REMARKS

AMENDMENTS TO THE DRAWINGS

Fig.16
BACKGROUND ART

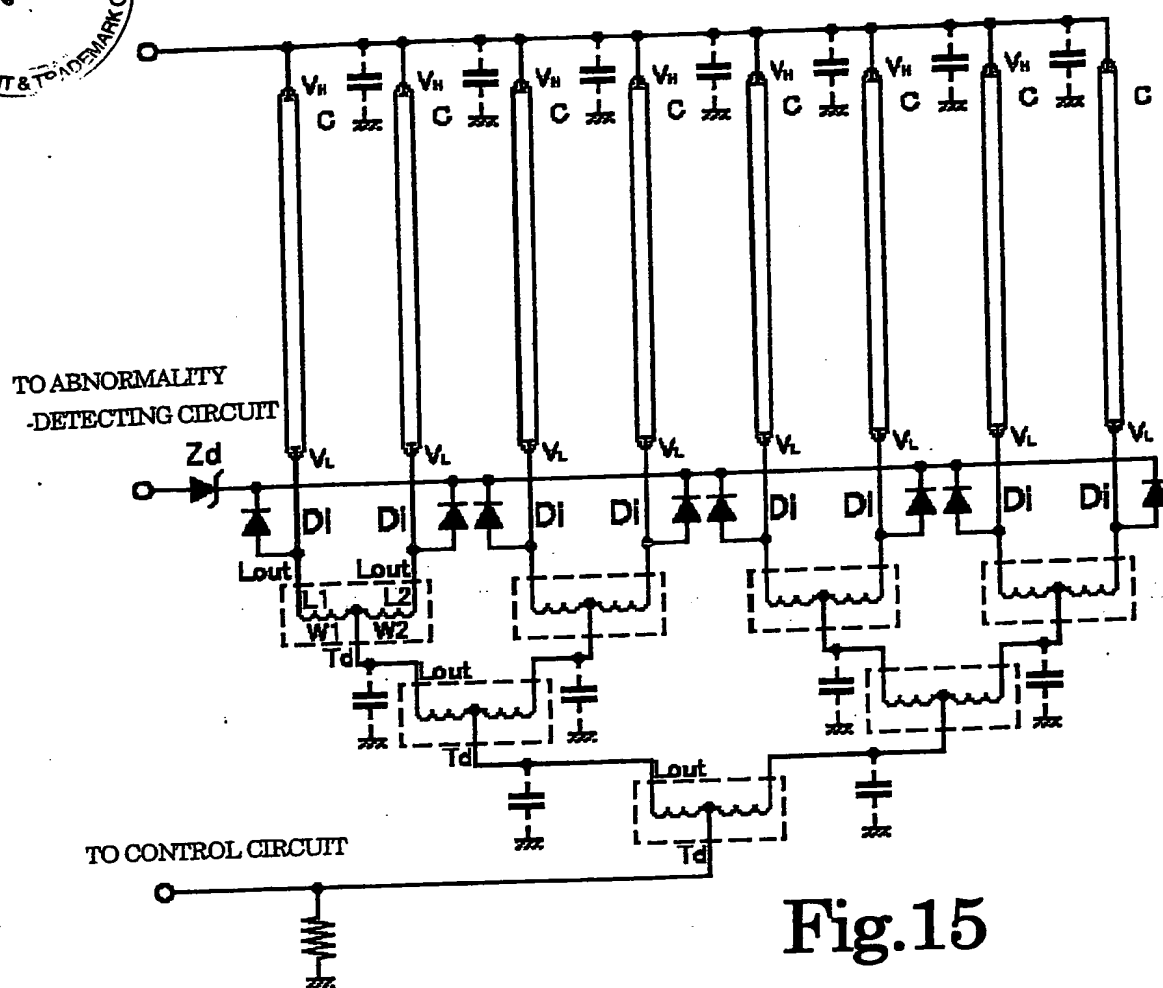
In the Office Action, the Examiner objected to Figs. 16-21 and 24, asserting that these drawings require a legend indicating that only that which is old is illustrated. Attached hereto are drawing corrections to Figs. 16-20 and 24 in which the legend of --BACKGROUND ART-- has been added. However, as to Fig. 21, Applicant respectfully disagree with the Examiner that such a legend is necessary. Specifically, Fig. 21 relates to one embodiment of the present invention in which the illustrated obliquely wound windings are used. See, e.g., claim 13.

The attached sheet(s) of drawings includes changes to Figs. 16-20, 22, and 24. In Figs. 16-20 and 24, the label --BACKGROUND ART-- has been added. Fig. 22 has been separated into Figs. 22a-22d, and certain reference numerals and captions have been deleted. Furthermore, Figs. 22e and 22f have been added.

~~Fig. 22~~

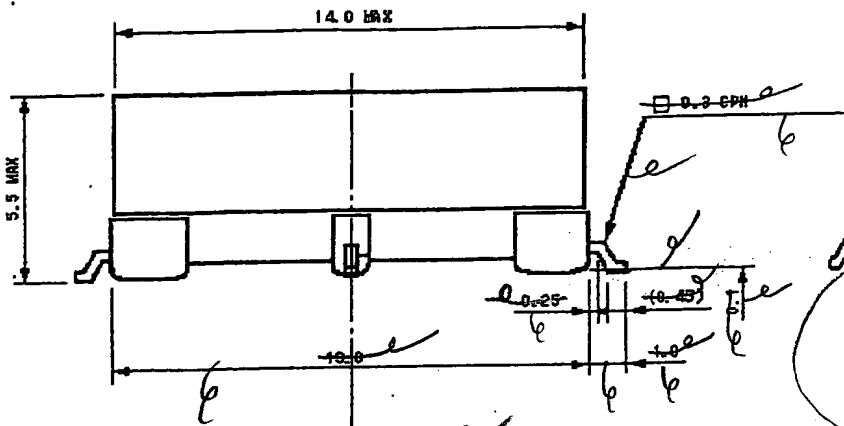
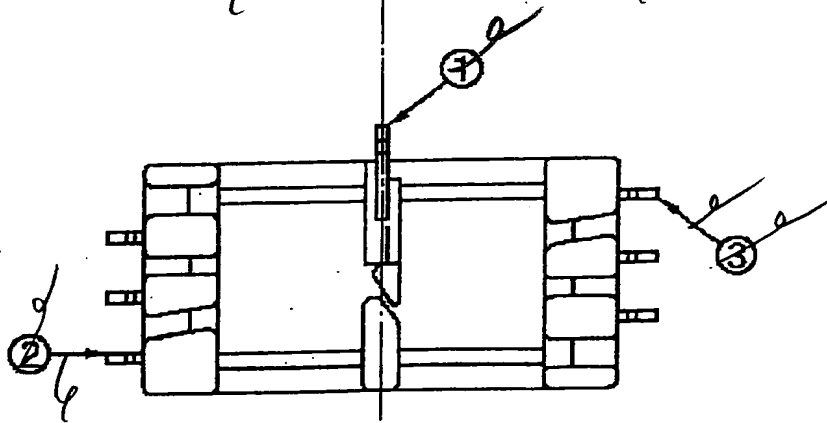
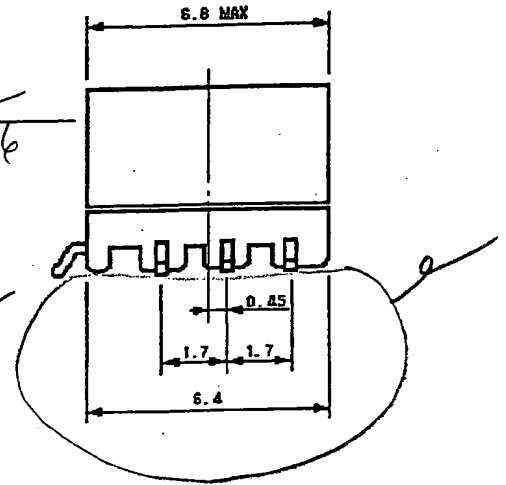
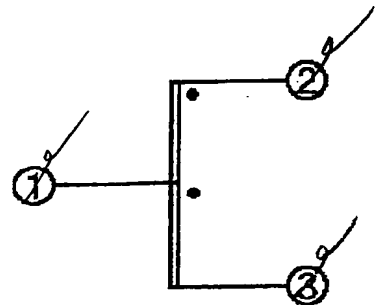
Furthermore, the Examiner objected to reference numerals 1, 2, and 3 in Fig. 22. In the attached drawing corrections, reference numerals 1, 2, and 3 have been removed. Furthermore, Fig. 22 has been separated into Figs. 22a-22d, as suggested by the Examiner.
